CERTIFICATE OF THE SECRETARY OF ENERGY AND ENVIRONMENTAL AFFAIRS
ON THE
THIRD NOTICE OF PROJECT CHANGE

PROJECT NAME : Kendall Square Urban Redevelopment Plan (KSURP) -
Amendment #11
PROJECT MUNICIPALITY : Cambridge (Kendall Square)
PROJECT WATERSHED : Charles River
EEA NUMBER : 1891
PROJECT PROPONENT : Cambridge Redevelopment Authority
DATE NOTICED IN MONITOR : September 22, 2021

Mitigation level – Residential

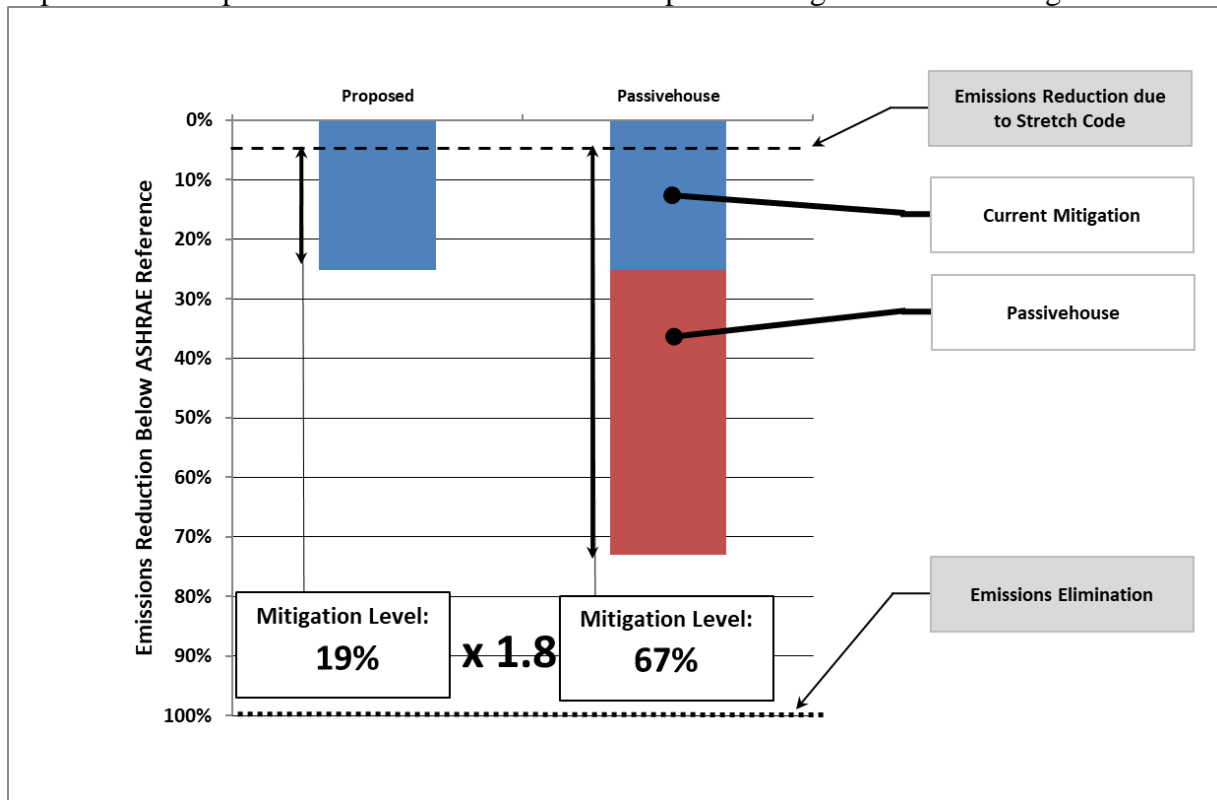
Mitigation Level for the residential building is 19%. This ML is largely achieved through improved envelope and full electrification of both space heating and water heating.

ML could be improved by x1.8 to 67% with Passivehouse design. Passivehouse would could also enable the project to access \$1.12M in MassSave incentives.
